# Santa Monica Hornburg Jaguar Expansion

**Final  
Environmental  
Impact Report**  
SCH No. 2003041146

## **Letter 1—Los Angeles Department of Transportation, August 11, 2003**

**FIGURE 3**

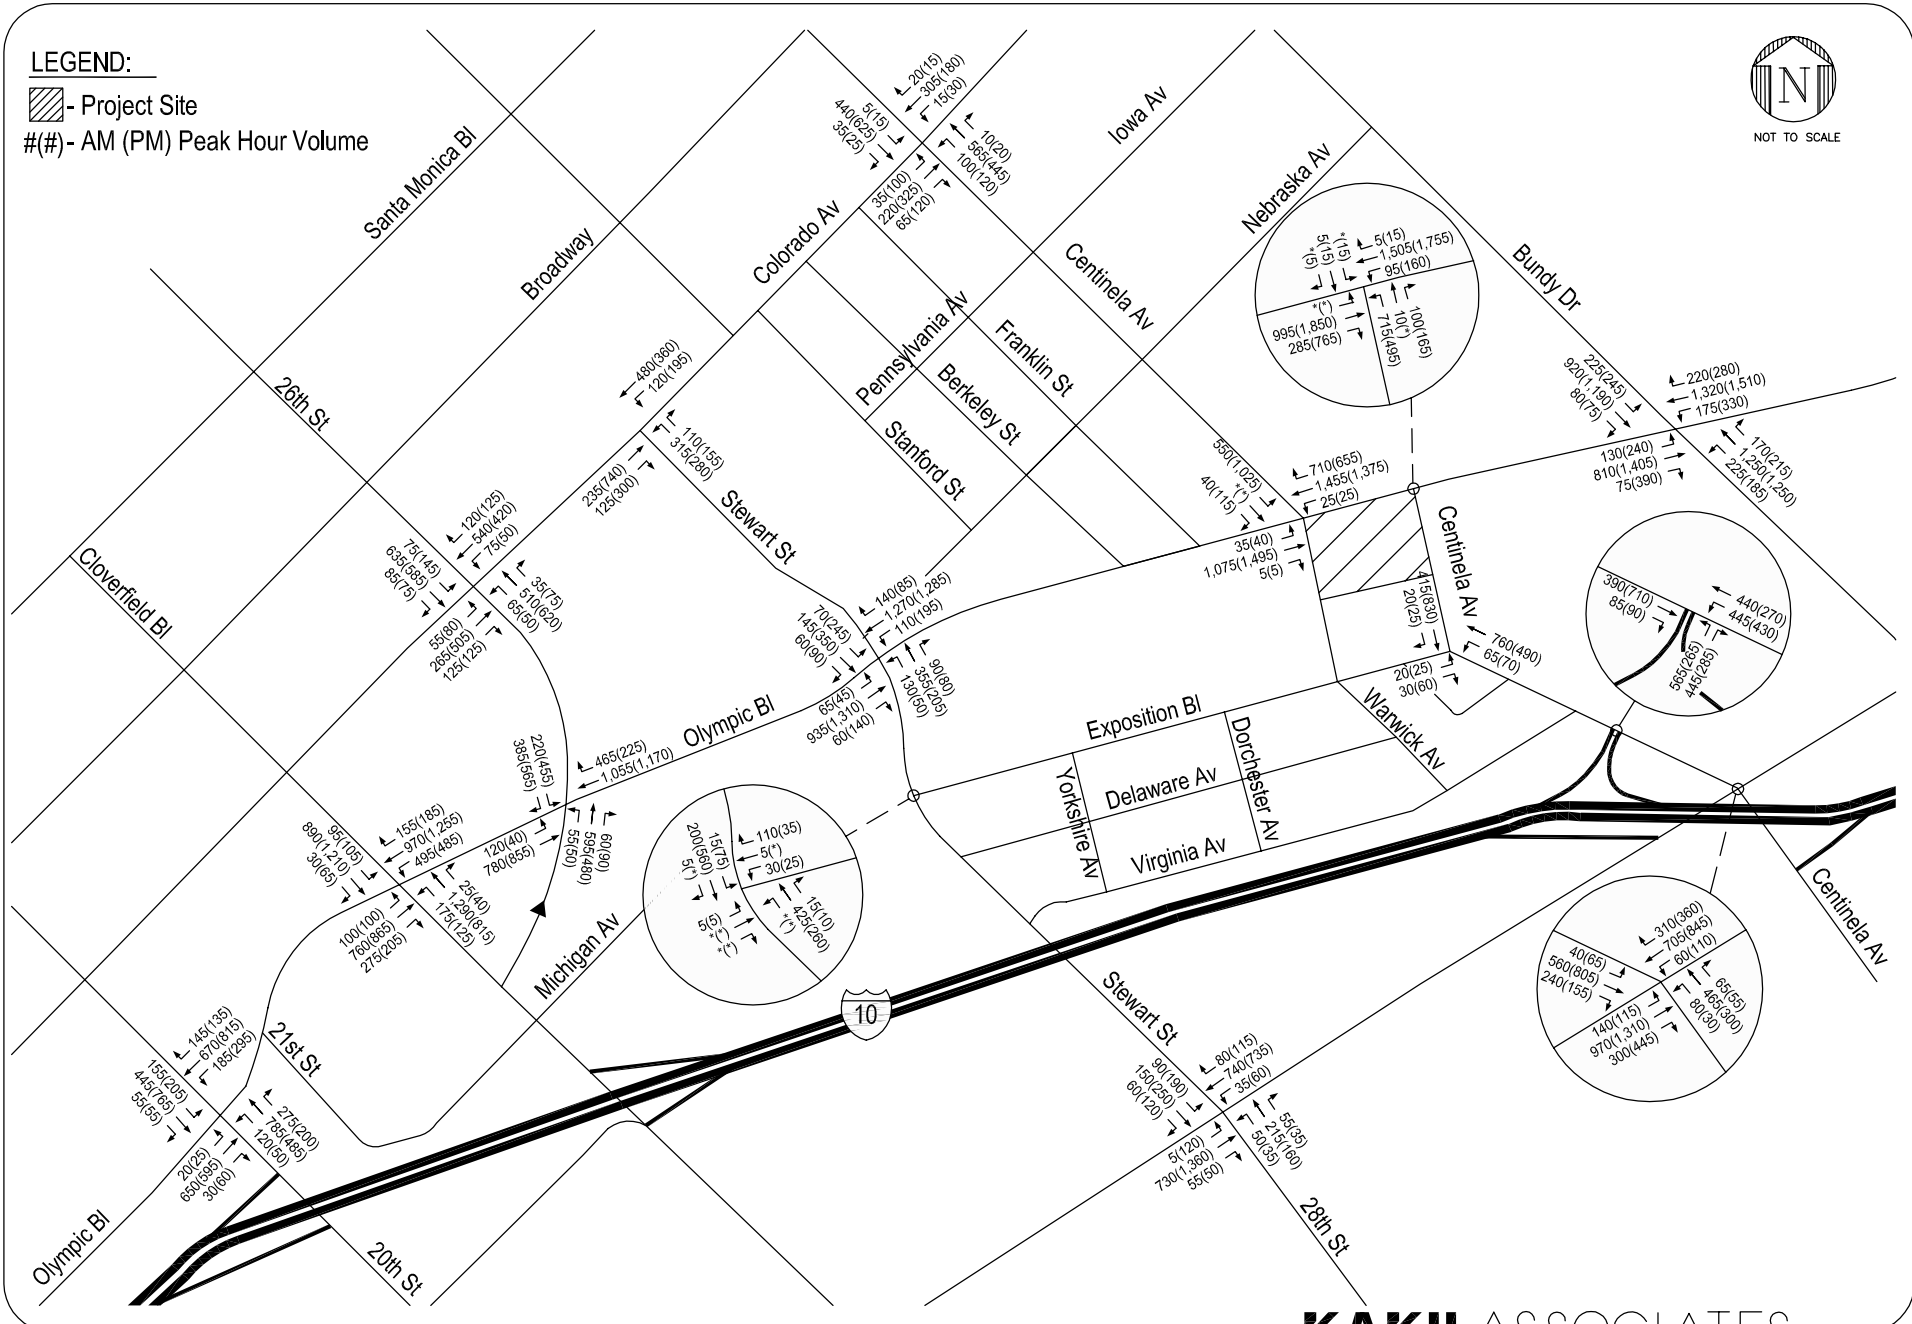
### *Page 9, Figure 3 (Existing Peak Hour Traffic Volumes)*

Traffic volumes shown in the four magnified intersections have been revised to reflect the analysis. Only the figure in the Draft EIR was in error: the analysis was based on the correct traffic volumes, which have been provided in the revised figures, and the conclusions of the analysis are not affected. The revised figure is provided below.

While our Signal Timing Section staff was conducting a left-turn analysis for the intersection of Centinela and Pico, they brought to my attention that on Figures 3, 4 and 7, there are some asterisks shown instead of the traffic volume. If the "\*" means negligible volume as the legend indicates in Figure 6, it does not quite make sense.

The comment incorrectly asserts that the Draft EIR does not contain sufficient information regarding turning movements in the vicinity of Centinela Avenue and Pico Boulevard. Although, as stated in Section 2.2 (Text Changes) of this Final EIR, Figures 3, 4, and 7 of the traffic study prepared for the project (Appendix D to the Draft EIR) depicted incorrect turning volumes for three intersections, the correct data were included in the analysis and are referenced beginning on page 6 of the traffic study. Additionally, the three figures have been revised and are included in Section 2.2 (Text Changes) of this Final EIR. However, the changes to the figures *do not* alter the analysis or its conclusions.

**FIGURE 4**

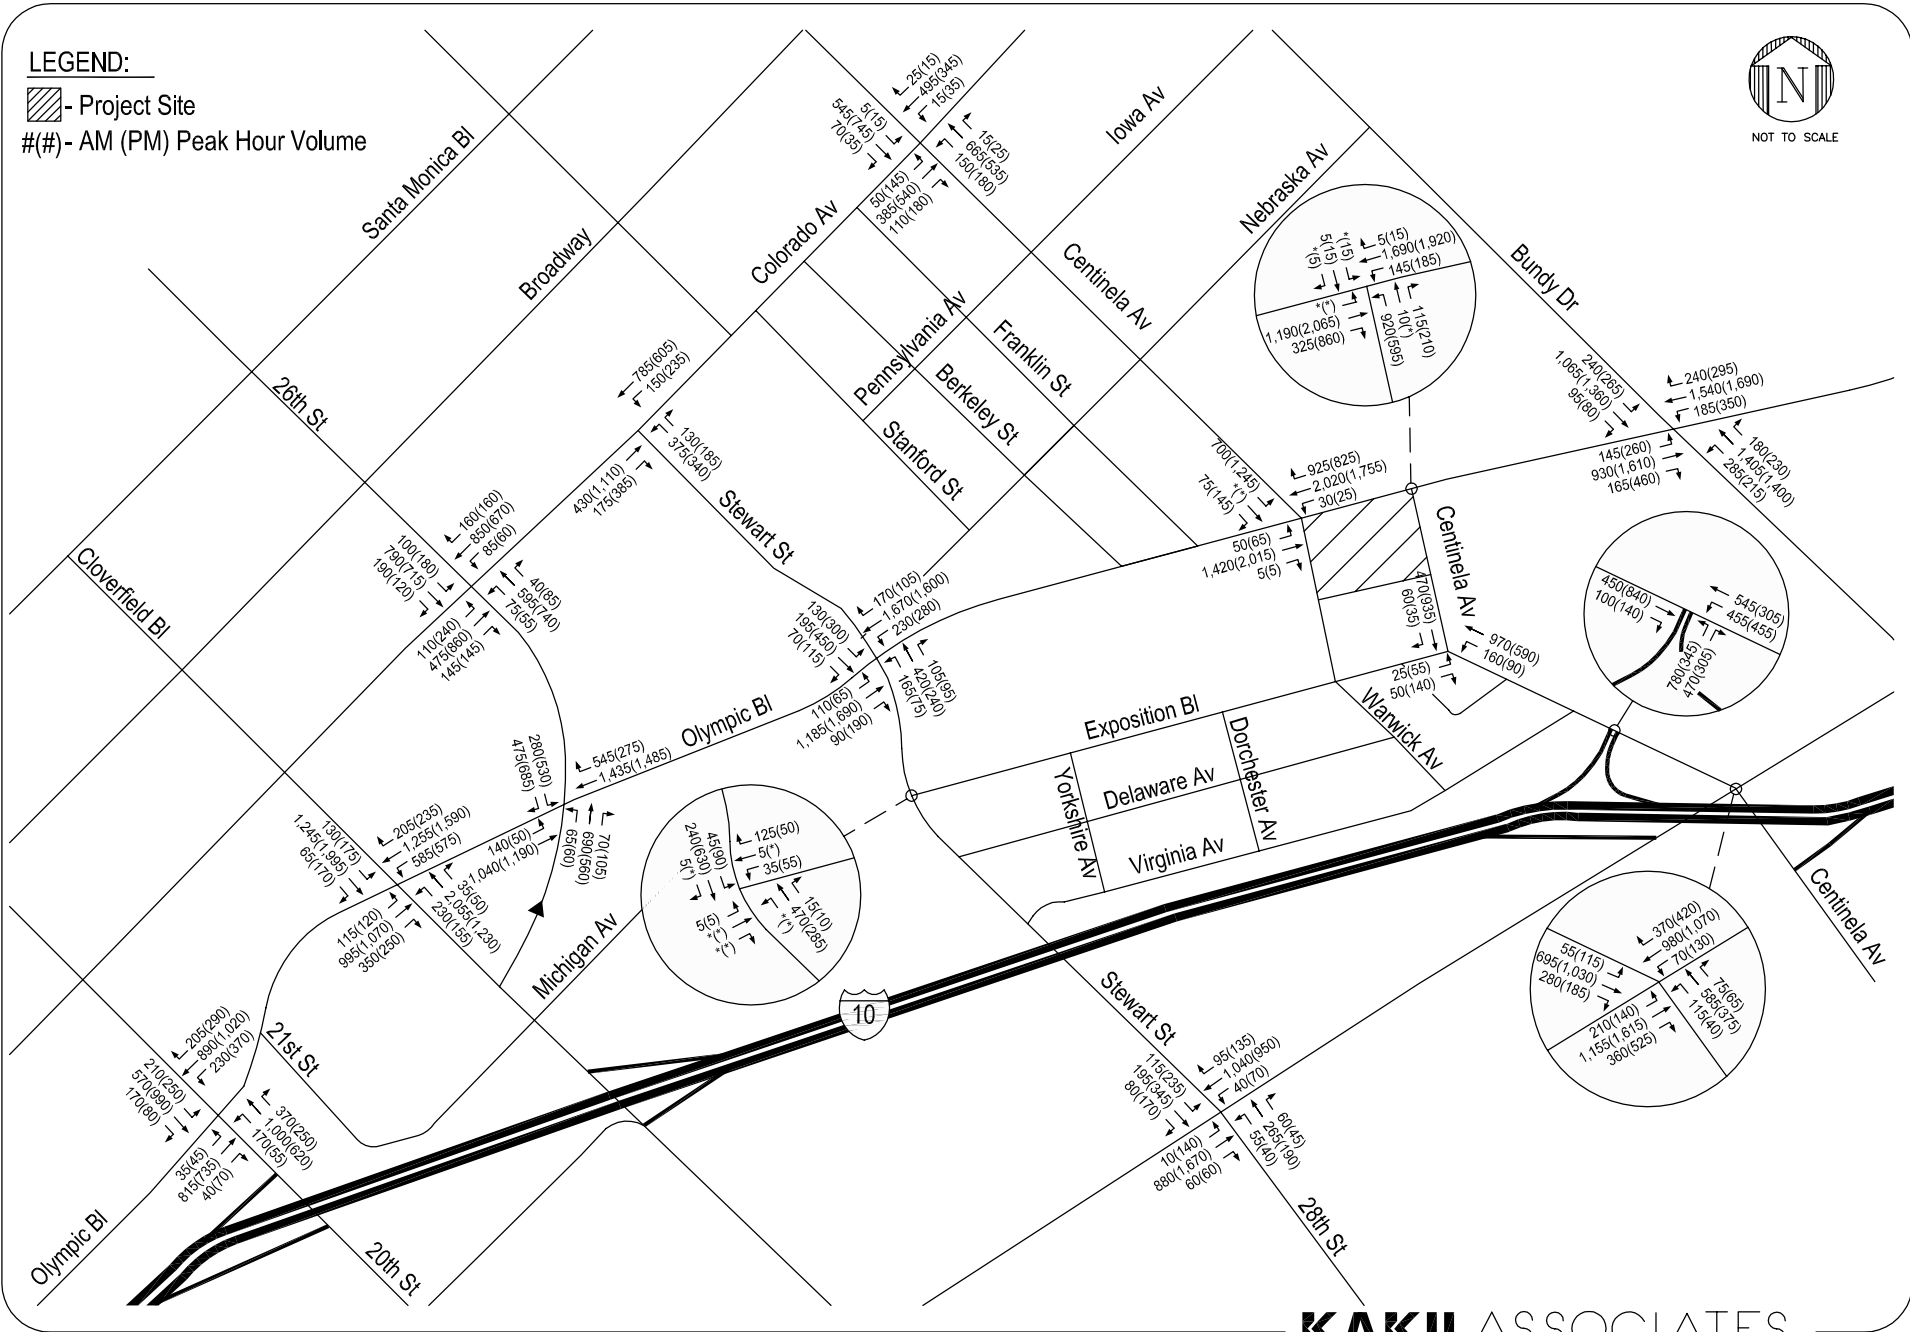
### *Page 21, Figure 4 (Cumulative Base [2009] Peak Hour Traffic Volumes)*

Traffic volumes shown in the four magnified intersections have been revised to reflect the analysis. Only the figure in the Draft EIR was in error: the analysis was based on the correct traffic volumes, which have been provided in the revised figures, and the conclusions of the analysis are not affected. The revised figure is provided below.
